# STORMWATER SITE PLAN REPORT

# STEP BY STEP EARLY LEARNING CENTER

C&A PROJ # 21-003

JULY 9, 2024

## EXISTING CONDITIONS MAP

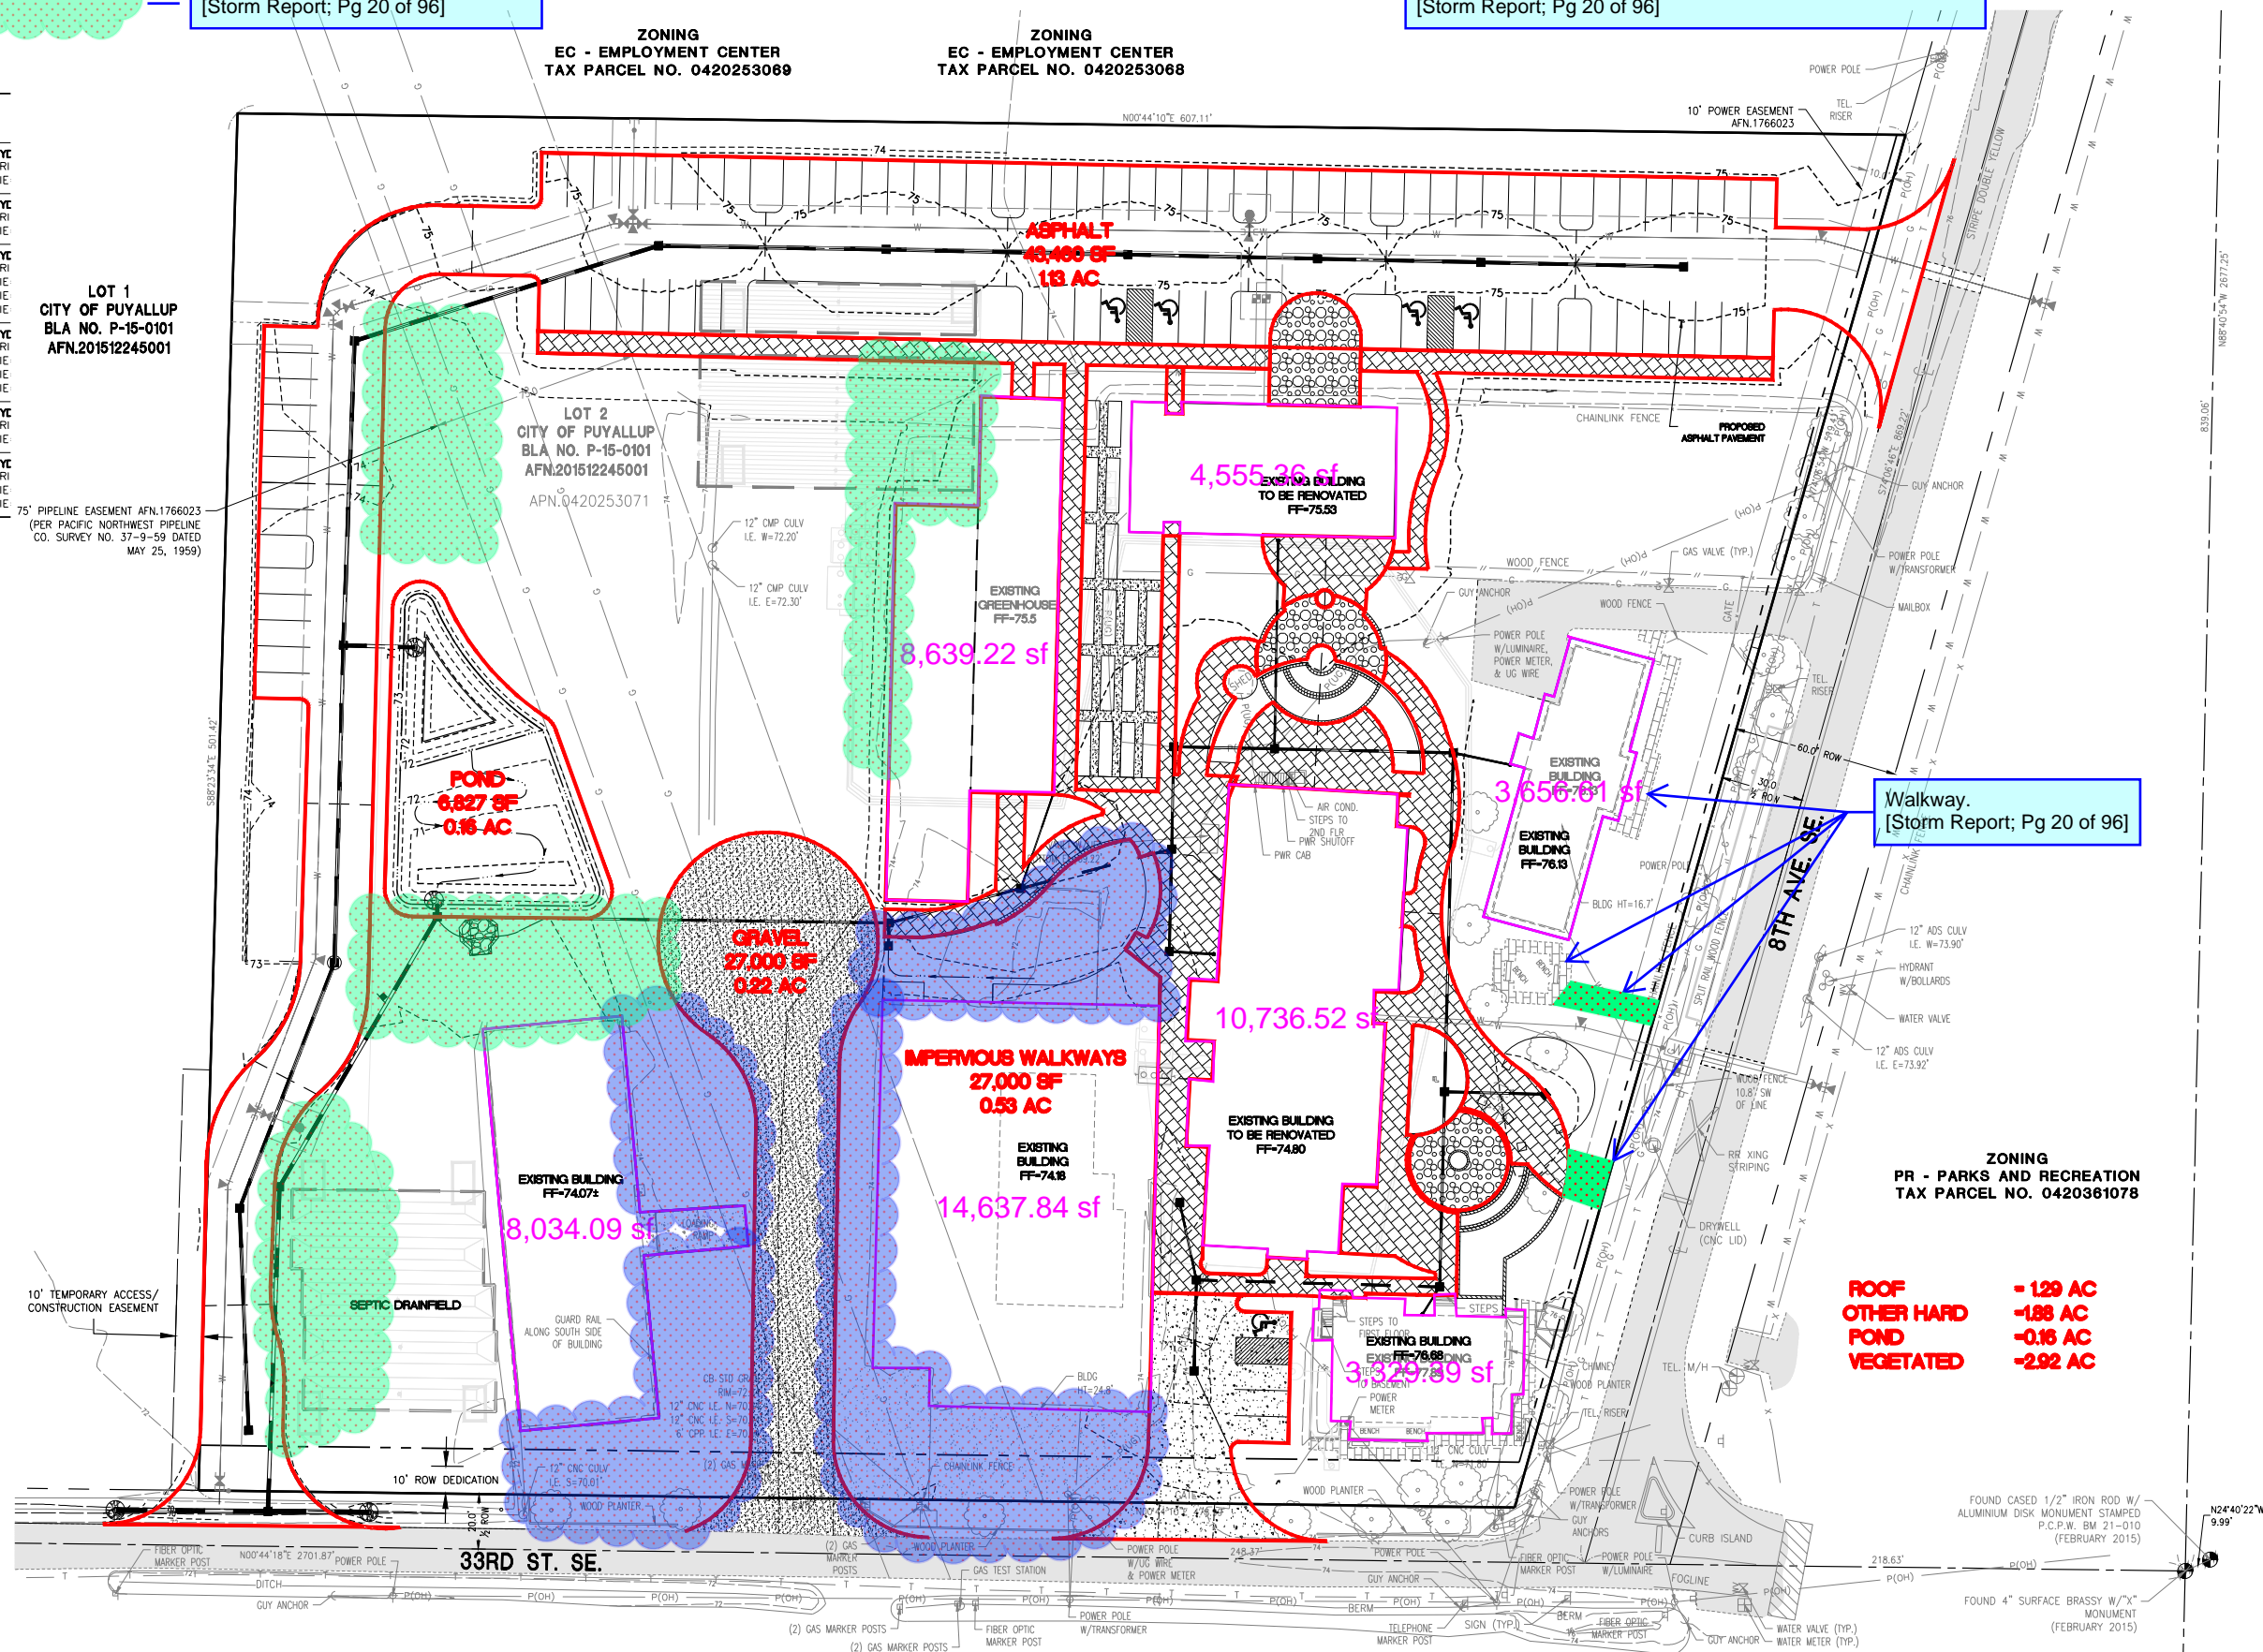
Add a category for all of the gravelled areas that exist at the time of this writing (see Existing Conditions Map). [Storm Report; Pg 14 of 96]

Revise per 'Existing Conditions Map' comments.  
[Storm Report; Pg 25 of 96]

Table Updated to address this comment.

Calcs have been updated per comment
